Memorandum

DATE: May 22, 2017

SUBJECT: A request for review of a Variance from Section 12-7B-16, Landscaping and Site Development, Vail Town Code, in accordance with Section 12-17, Variances, Vail Town Code, to allow for a reduction in landscape area, located at 231 Gore Creek Drive/Lot A, Block 5B, Vail Village Filing 1, and setting forth details in regard thereto. (PEC17-0009)

Applicant: Gasthof Gramshammer, Inc. / Pepi's Restaurant,
represented by Russell Gies, Gies Architects, Inc.

PROJECT: **PEPI'S BAR REMODEL**
231 E. Gore Creek Dr. - Vail, CO.
DRAWING: **PROPOSED ELEVATIONS**

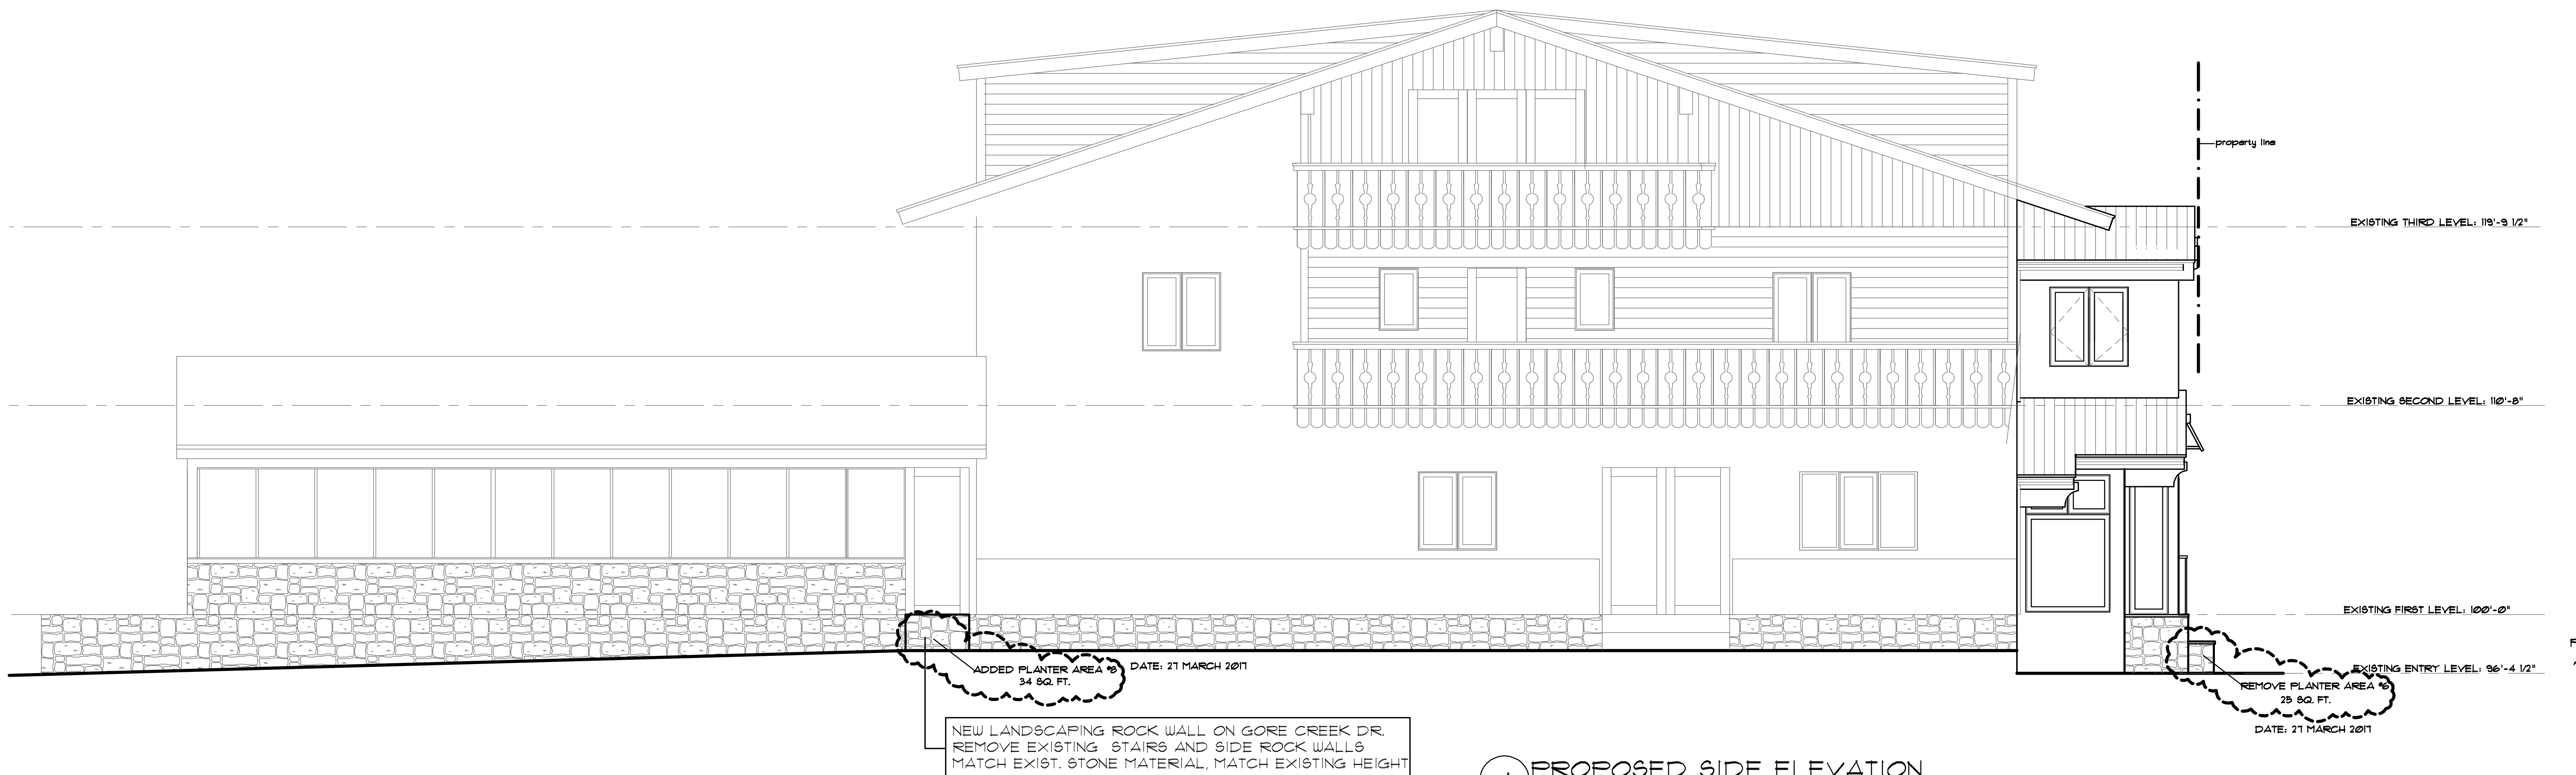
Gillette – How big is the planter by the slider doors? Geis – about 18 inches deep.

Hopkins – I have worked in the Village for years. Sheika does the most beautiful flowers. Why not add some removable planters along the slider doors?

C101

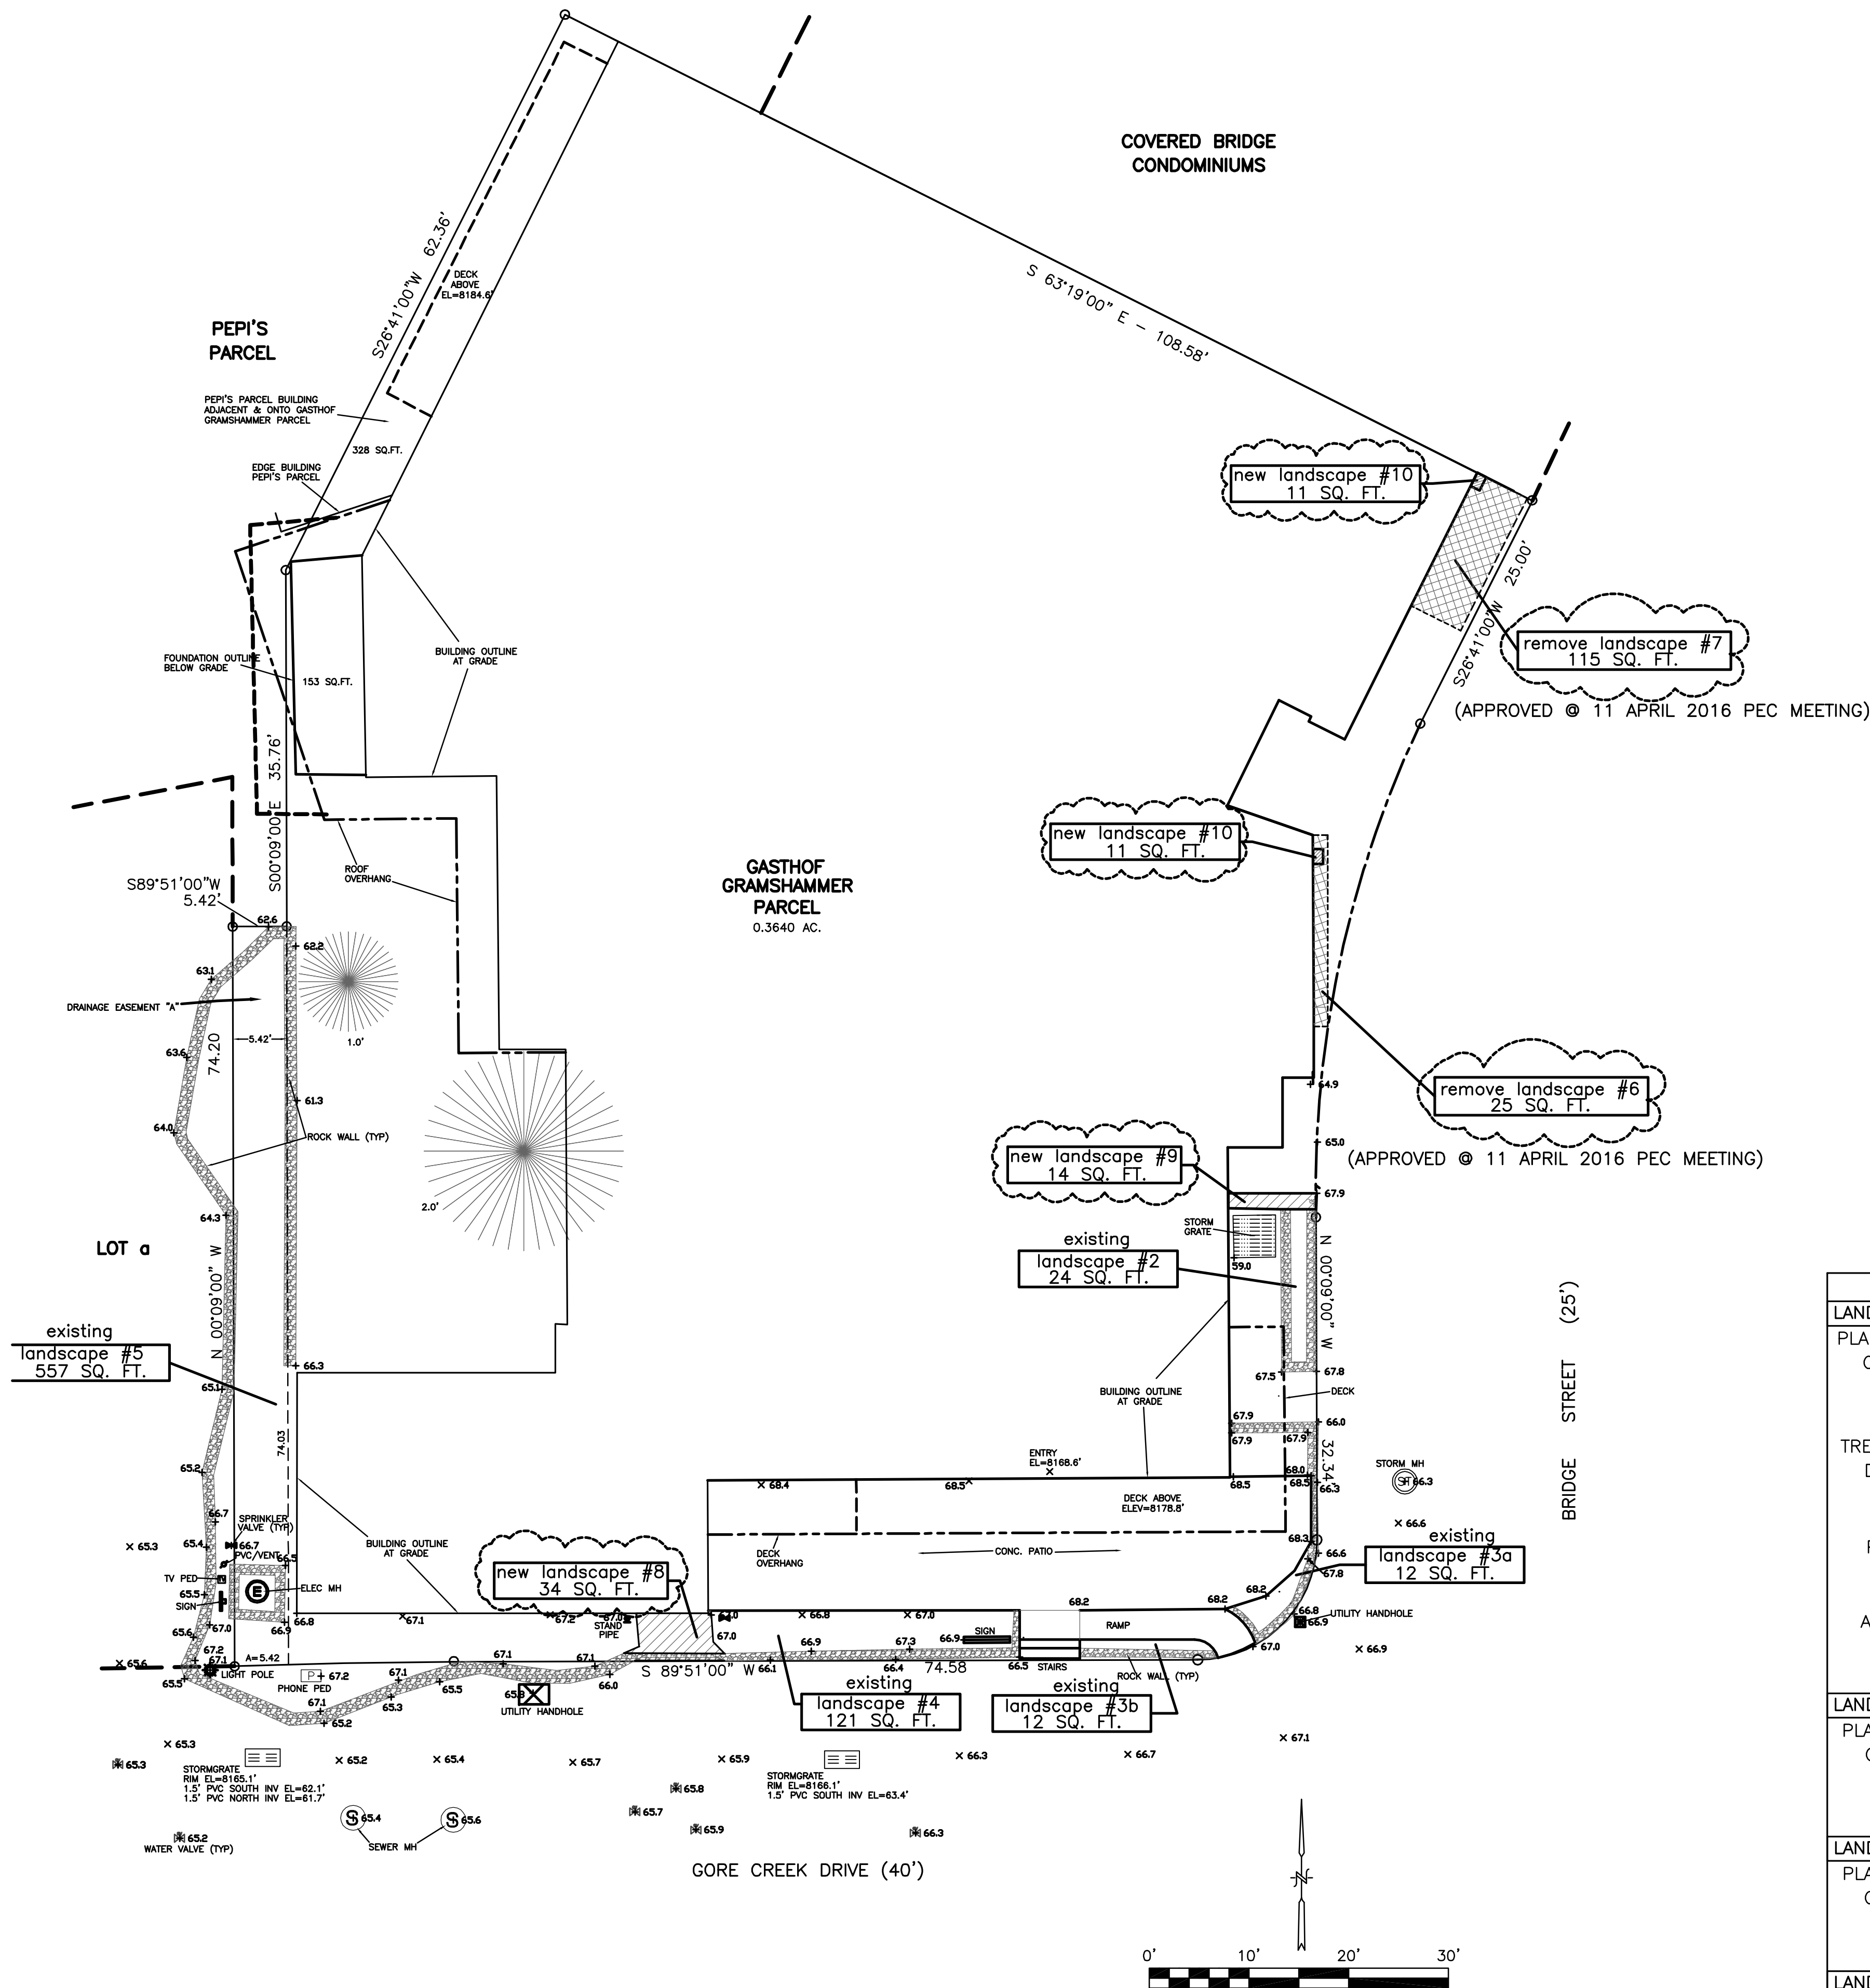
of the approved plans for PEC16-0011. Instead of the previously approved planter areas, the applicant is proposing to install two (2) 11 square foot planters and to add 14 square feet of landscaping to the retaining wall near the Bridge Street entrance and also 34 square feet of landscaping in front of the beer garden area along Gore Creek Drive. The resulting net reduction in landscaping versus the 2016 approved plans is 70 square feet.

Development Standard	Allowed / Required	Existing	Proposed	Change
Site Area	5,000 sq. ft.	15,856 sq. ft. buildable site area		No Change
Setbacks	No setbacks required by the Urban Design Guide Plan			No Change
Building Height	43' for up to 40% of building, 33' for remainder of building	53.3% between 33'43' and 46.7% under 33'*		No Change
Site Coverage	Max. 80%	12,563 sq. ft. (79.2%)		No Change
Landscaping	No reduction allowed	863 sq. ft.**	793 sq. ft.	- 70 sq. ft.

The subject property is bordered on all sides by similar mixed-use structures and identical Commercial Core 1 District zoning. If approved, the removal of landscaping is counter to established goals and recommendations identified in the Vail Village Master Plan and Vail Village Urban Design Guide Plan. Specifically, the Vail Village Urban Design Guide Plan encourages, “berms, grass, flowers and tree planting as a soft, colorful framework linkage along pedestrian routes. Also, the Vail Village Master Plan established a goal, “to recognize as a top priority the enhancement of the walking experience throughout the village.” The first objective to accomplish this goal is to, “physically improve the existing pedestrian ways be landscaping and other improvements.” (see pages 4 and 5).

The intent of landscape requirements within the Commercial Core 1 District and Vail Village Urban Design Guide Plan area is to provide a colorful framework linkage along pedestrian routes. Staff finds that the strict and literal interpretation of the landscaping standards does not impose on the applicant any hardship different from any other similarly zoned site. In fact, in PEC16-0011, the applicant already demonstrated the feasibility of meeting the minimum landscape requirements. The proposed removal of landscape area is not a physical necessity.

Staff finds that granting the requested variance would be a grant of special privilege in that there are no exceptional or extraordinary circumstances or conditions applicable to the subject property that do not apply generally to other properties located within the Commercial Core 1 District.

Panfil introduced the application. Code requires no net reduction in landscaping. He displayed the previously approved plans that showed the approved location of landscaping. Applicant is proposing to remove some of the landscaping planters as previously approved. Applicant would like to add some landscaping planters and vertical planters on the building walls, instead of approved planters. Also, near the beer tent, some additional landscaping is proposed where existing stairs are located (stairs are not used.)

Rediker – In 2016, was there a reduction in landscaping? (Panfil indicated no.) There was some increase in landscaping, and should be built per the approved plan.

Based upon staff's review of the criteria outlined in Section VII of this memorandum and the evidence and testimony presented, the Community Development Department recommends **denial** of the proposed landscaping variance, subject to the findings noted in Section VIII of this memorandum.
